UNITED STATES
NUCLEAR REGULATORY COMMISSION
WASHINGTON, D. C. 20555

February 6, 1981

Docket Nos. 50-259
50-260
and 50-296

The Commission has issued the enclosed Amendment Nos. 66, 62 and 38 to Facility License Nos. DPR-33, DPR-52 and DPR-68 for the Browns Ferry Nuclear Plant, Unit Nos. 1, 2 and 3. These amendments which are in response to your applications dated June 13, 1980 (TVA BFNP TS 139) and October 16, 1980 (TVA BFNP TS 152), change the Technical Specifications to (1) revise the definitions for "Limiting Conditions for Operation" and "Operability" to be consistent with the definitions in the model technical specifications enclosed with our generic letter to you of April 10, 1980, and (2) revise the definition of "Cold Shutdown" to be consistent with the "Standard BWR Technical Specifications".

Figure 3.6-1

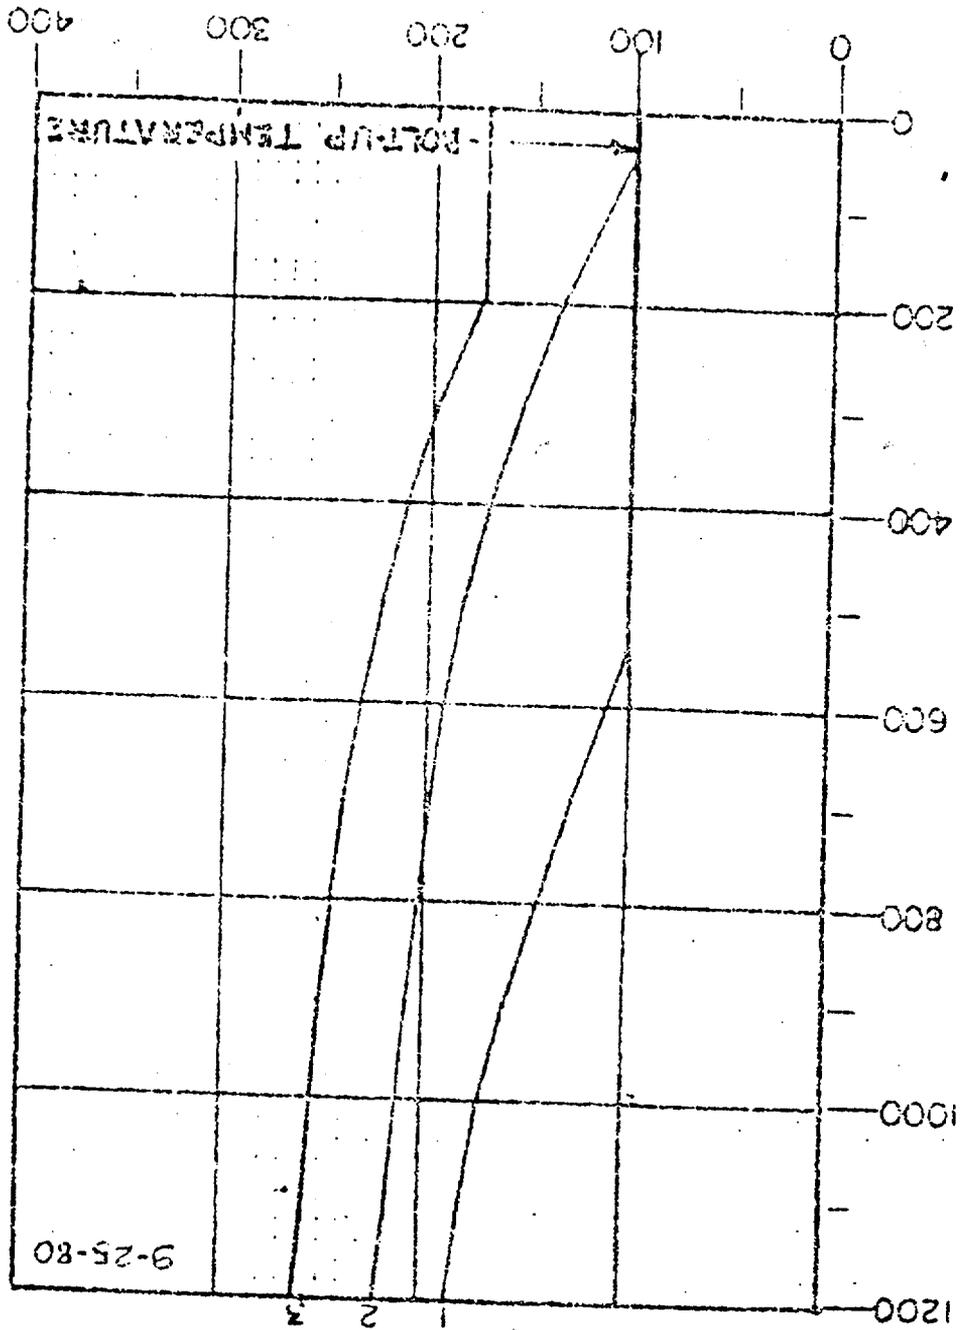
These curves are plotted 30° to the right of the original set of curves to include a margin of 30° F. This shift will allow these curves to used thru 4.0 BPPY.

The proposed changes on page 188 of the Unit 1 and 2 Technical Specifications and on page 201 of the Unit 3 Technical Specifications is to substitute a revised Nil Ductility Temperature (NDT) operating curve. These curves specify the minimum temperature that the reactor vessel must be at for the range of primary coolant pressures. The upper portion of the curves provides an additional 20°F shift from the original curves for protection because of uncertainty of radiation damage. The lower portion of curves 2 and 3 reflect the limiting conditions for protection of the feedwater nozzles from degradation. This lower portion includes the 40°F conservatism for nuclear heatup. These proposed curves are more conservative than those in the present technical specifications and have been administratively imposed. The proposed changes are acceptable.
